Peter E. Katz
Vice President
Calvert Cliffs Nuclear Power Plant
Constellation Generation Group, LLC

SUBJECT: Calvert Cliffs Nuclear Power Plant
Unit Nos. 1 & 2; Docket Nos. 50-317 & 50-318
Response to Request for Additional Information, Generic Letter 96-06

SERVICE WATER SYSTEM SIMPLIFIED ELEVATION SKETCH

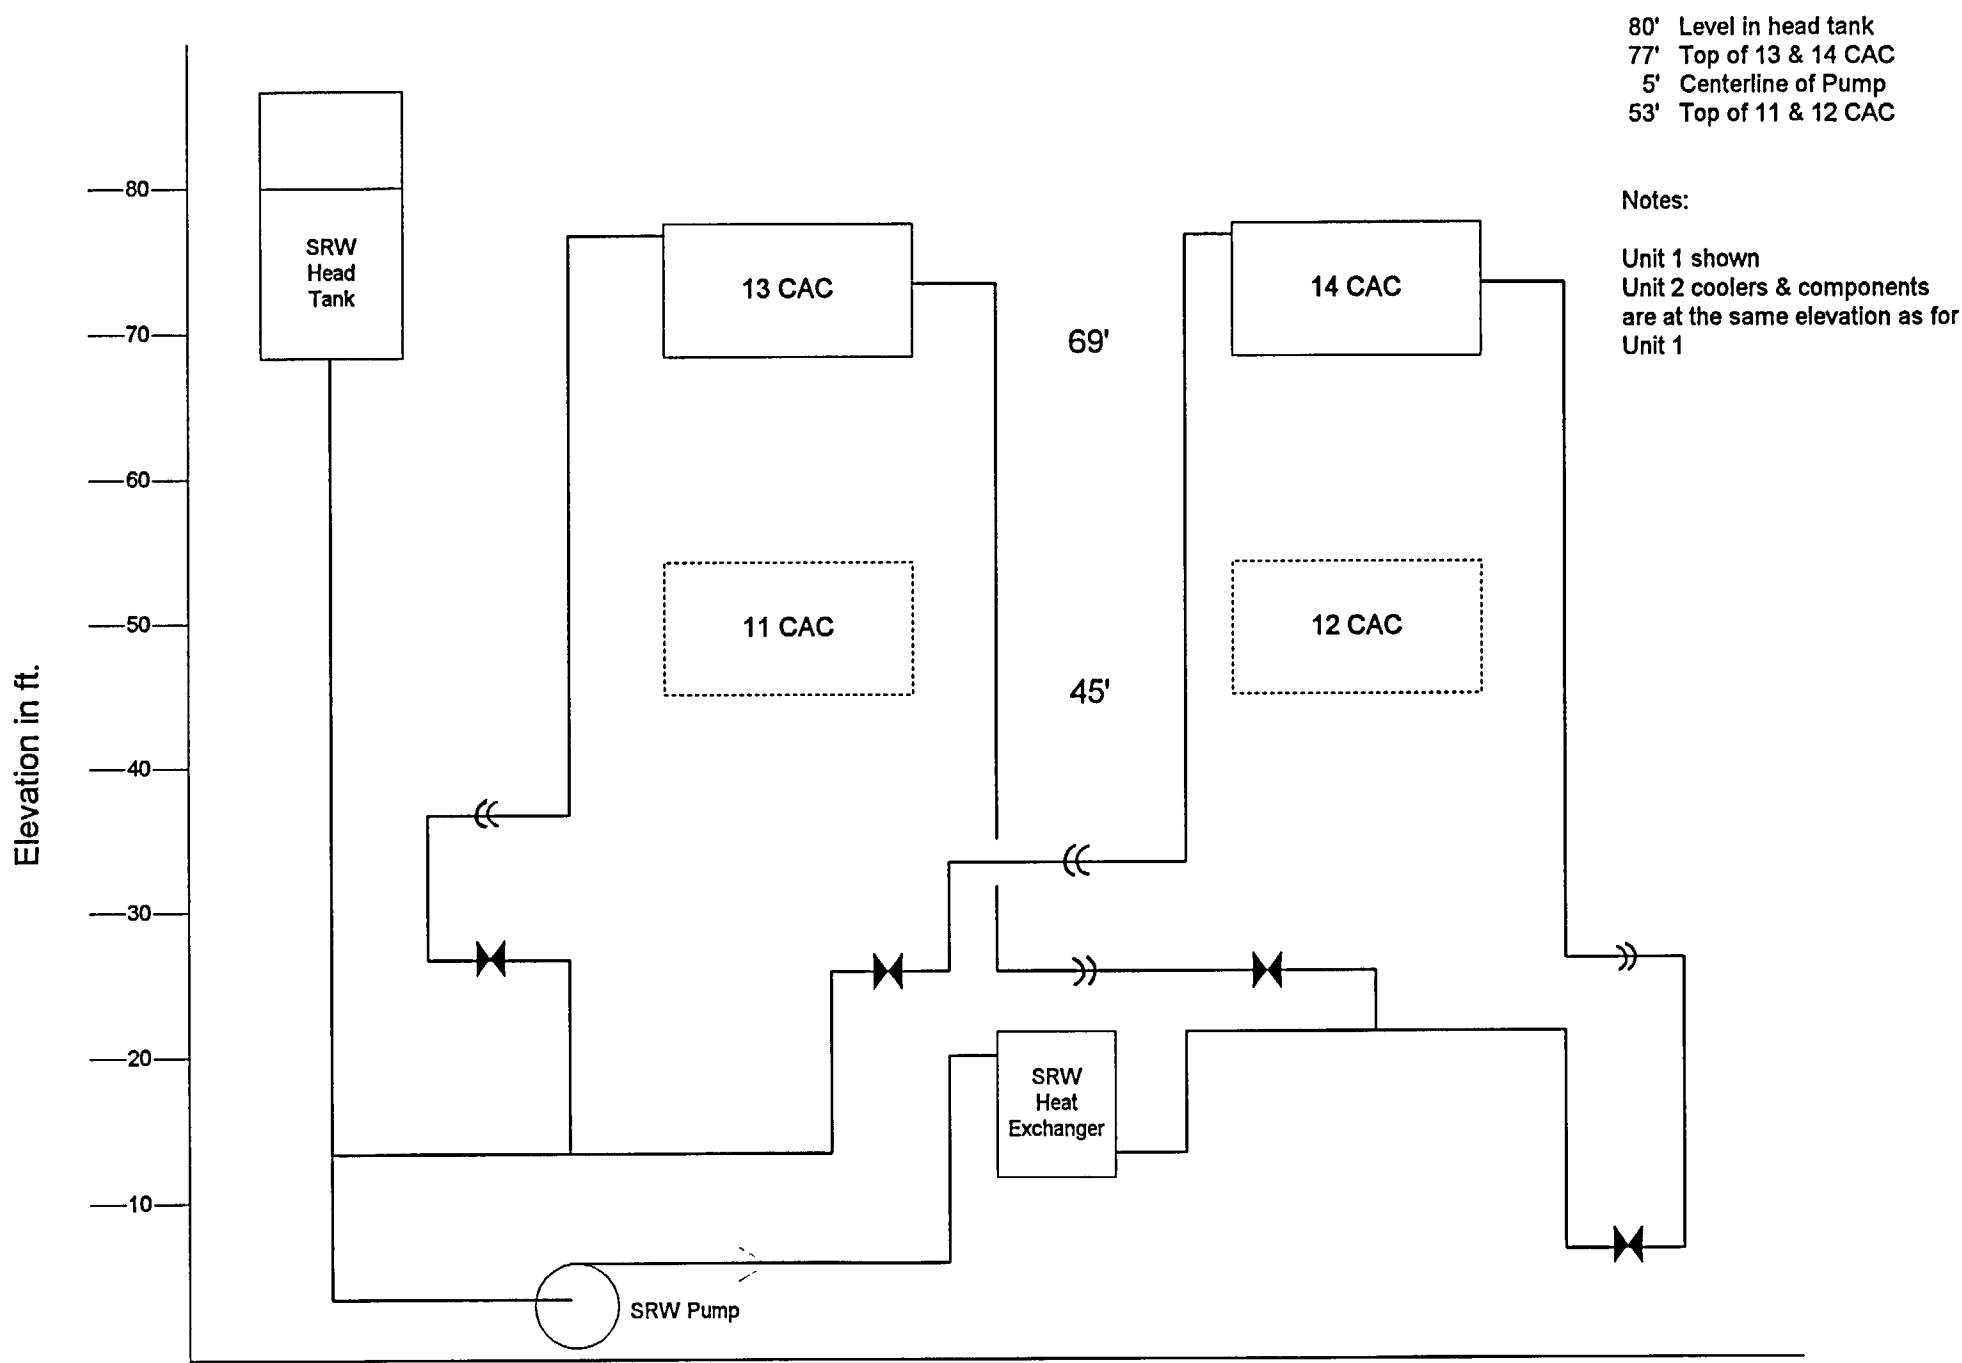
1. On July 25, 2002 (Reference f), Calvert Cliffs stated that waterhammer is the only remaining issue and several options to resolve it were being considered. Please provide a description of the option chosen.
2. Please provide a simplified elevation diagram showing the relative position of the service water (SRW) head tanks and the containment air coolers (CAC).
3. Please provide a discussion of the Generic Letter 96-06 worst case scenario as it applies to Calvert Cliffs.
4. Please provide a discussion of minimum margin to boiling in the SRW System with assumptions used in making this determination.
5. Please provide the results of the two-phase flow evaluation for the service water system.

The elevation drawing is attached to this letter.
